**CITY OF TUKWILA  
PLANNING COMMISSION (PC)  
AND  
BOARD OF ARCHITECTURAL REVIEW (BAR)  
AGENDA  
SEPTEMBER 22, 2022 - 6:30 PM**

**STAFF REPORT TO THE BOARD OF ARCHITECTURAL REVIEW  
PREPARED September 12, 2022**

FILE NUMBER: L22-0048

REQUESTS: Design Review approval for construction of a 121,156 square foot warehouse building with associated office space on an approximately 5.98-acre site along with associated site improvements.

Figure 1. Proposed building footprint

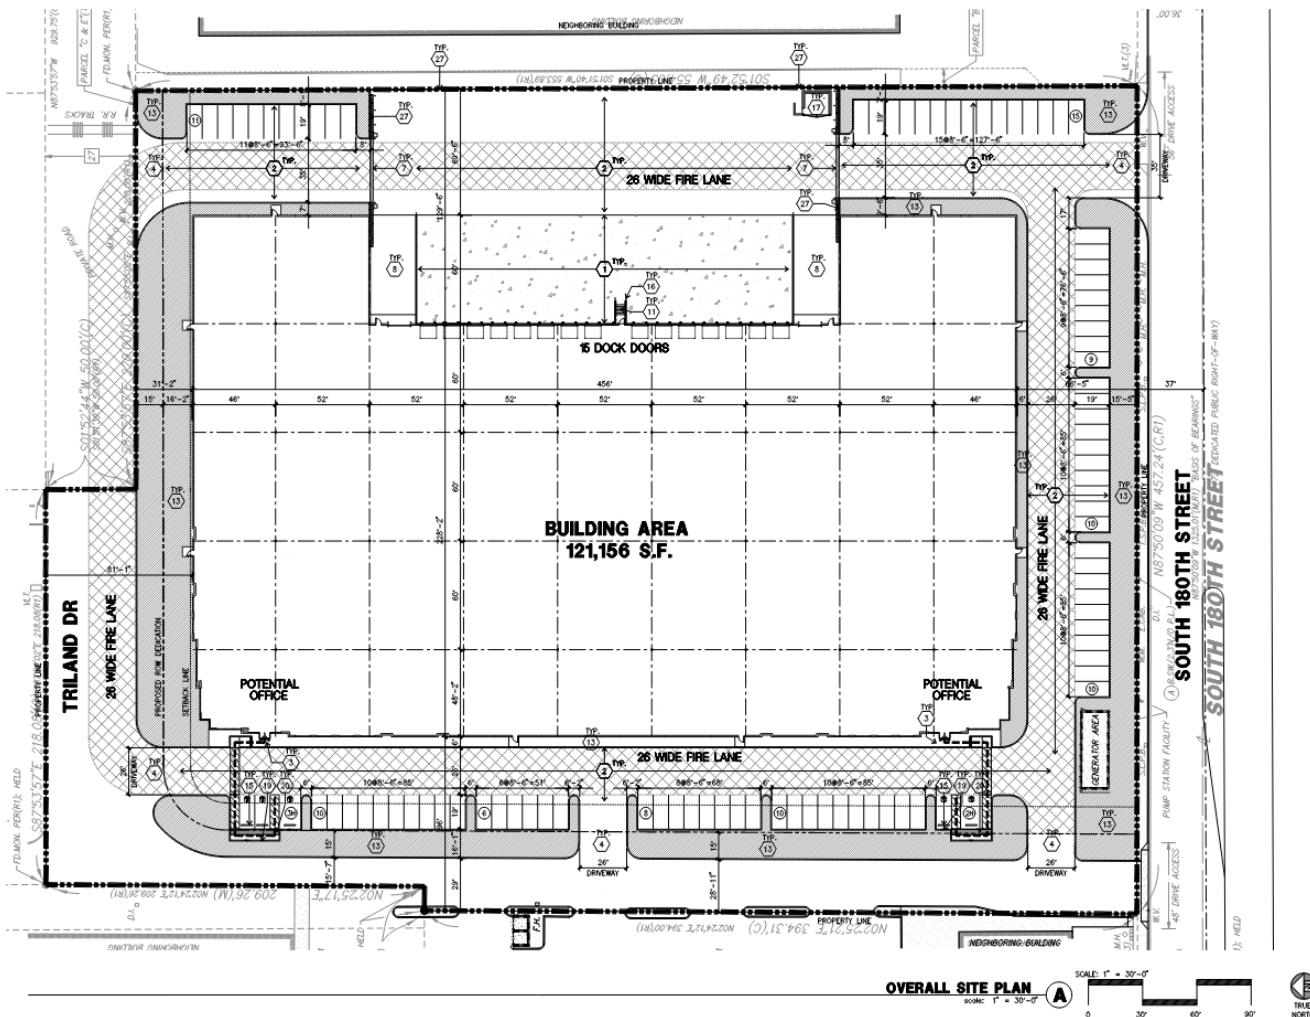
This project is to construct a 121,156 square foot warehouse building with associated office space on an approximately 5.98-acre site along with associated site improvements. The project will also establish new public streets at unimproved portions of Triland Drive and an unnamed Workplace Corridor on the west side of the parcel.

Figure 3. Corridor Map. Approximate site shown with orange star.

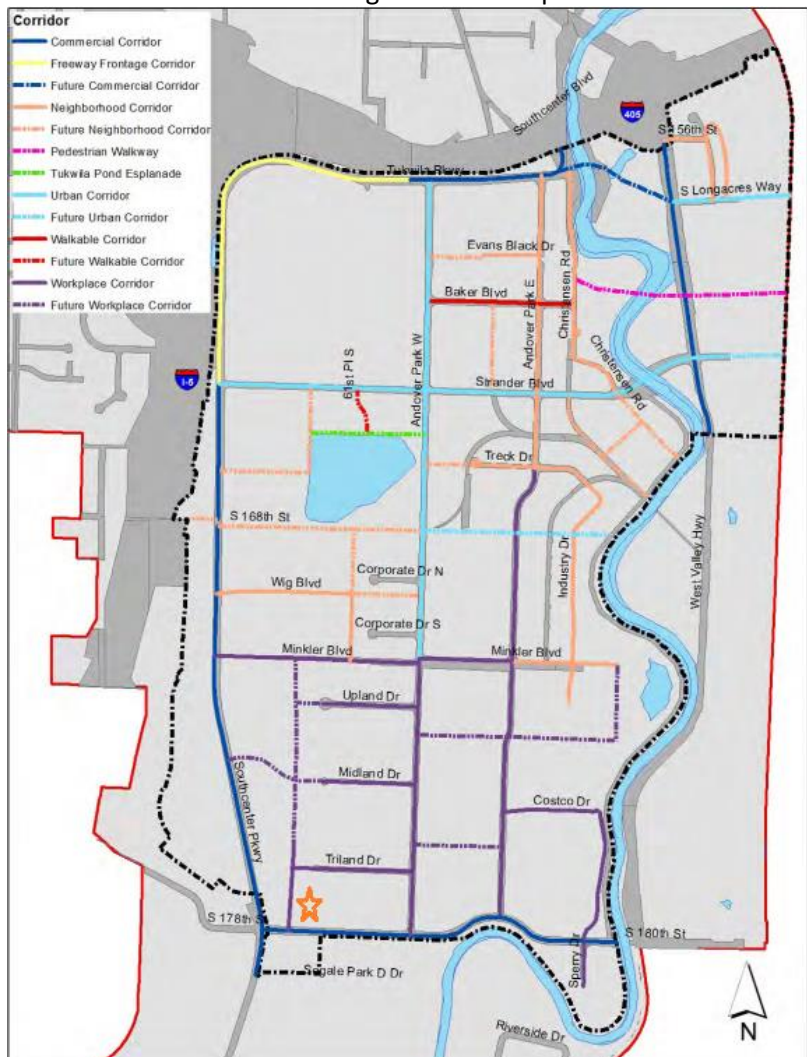
As shown in figure 3, Triland Drive and the unnamed access road on the west portion of the property are both considered Workplace Corridors. South 180<sup>th</sup> Street is considered a Commercial Corridor. See attachment D for the Corridor Standards sheets.

Enlarged View of West Elevation

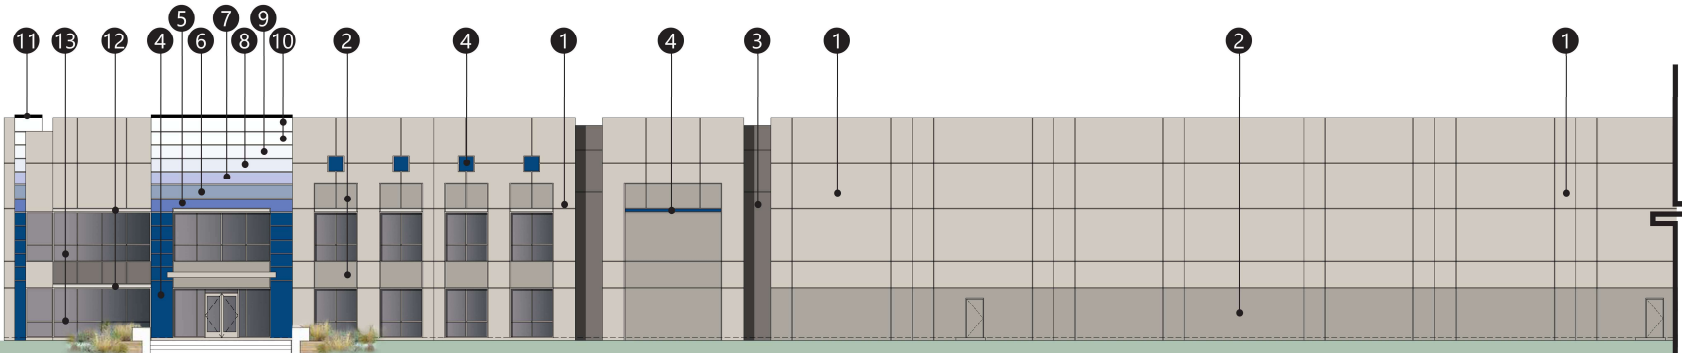
Architectural detail is proposed that will provide visual interest to the proposed building including color scheme, and large windows.
